NASA GLENN RESEARCH CENTER
UPGRADE ELECTRIC PROPULSION 2-16-06
RESEARCH BUILDING 16
FY05 - Phase 2

(Solicitation No. NNC06ZDF018E)

A. CONTRACTOR QUESTIONS AND ANSWERS (Electrical clarification only)

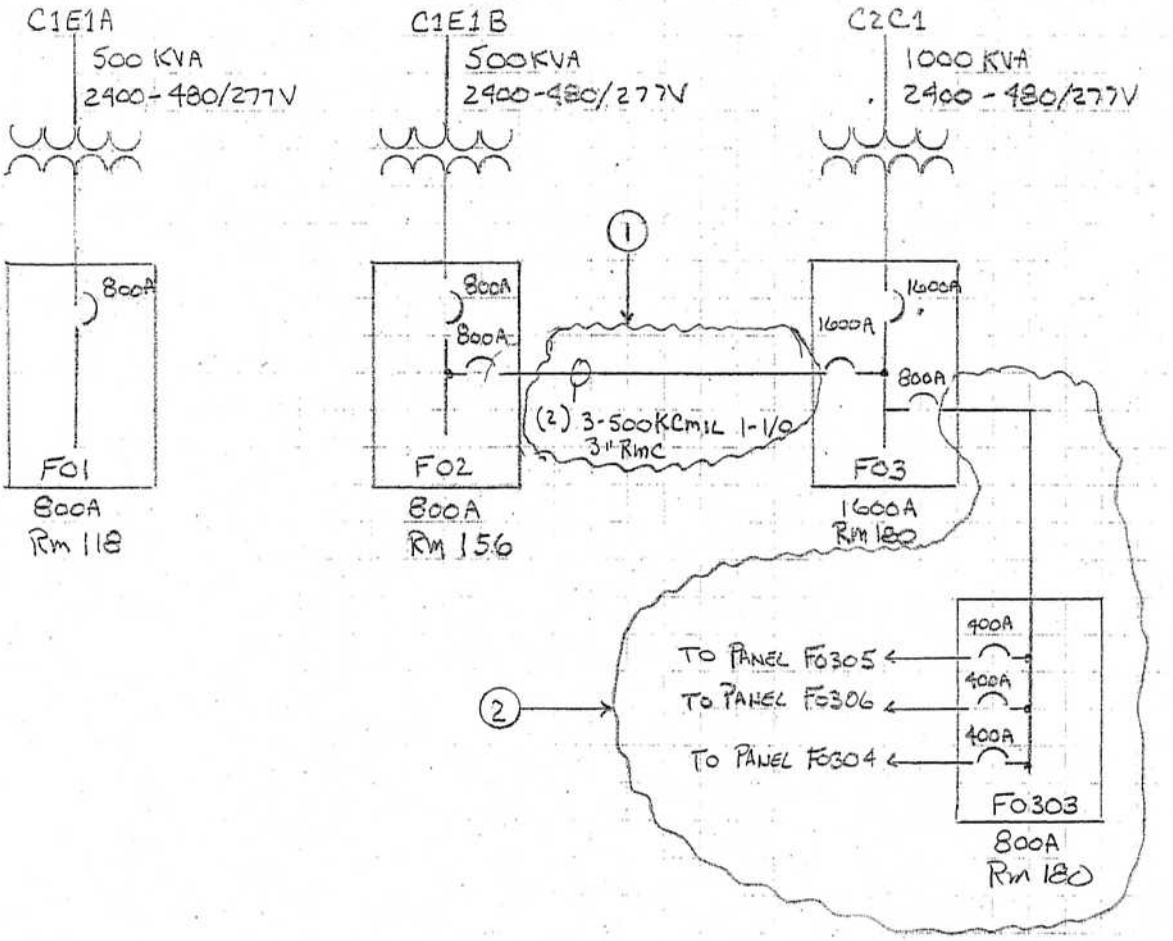
QUESTION NO. 26
The drawings due not indicate the option 4 work, it is shown on the drawings both demo and install with notes that make it seem that all of the work is base bid. Please clarify if the option 4 as stated in the specification is all inclusive of the work that shown on the drawings associated with the transformers.

- Prior to replacing transformer C1E1A the contractor shall install a new 480/277 volt, 1200amp switchboard in Room 180 to provide tie capabilities from draw-out switchgear F03 (located in room 180) to panel F01 (located in Room 118) during the transformer replacement. Included in this task is installing parallel 3" rigid metal conduits (RMC) and branch circuit conductors from the newly installed switchboard to panel F01. Refer to attached partial drawings 6 and 7 of 7, dated February 13, 2006.
- **Also, refer to attached partial drawings 1 of 2 and 2 of 2, dated February 16, 2006 for further clarification.**

Note 1 - Disconnect conduit and wiring from 1600A circuit breaker in room 180.

Note 2 – Disconnect and remove panel F0303 (return to Government). Remove feeders and conduit to F03.
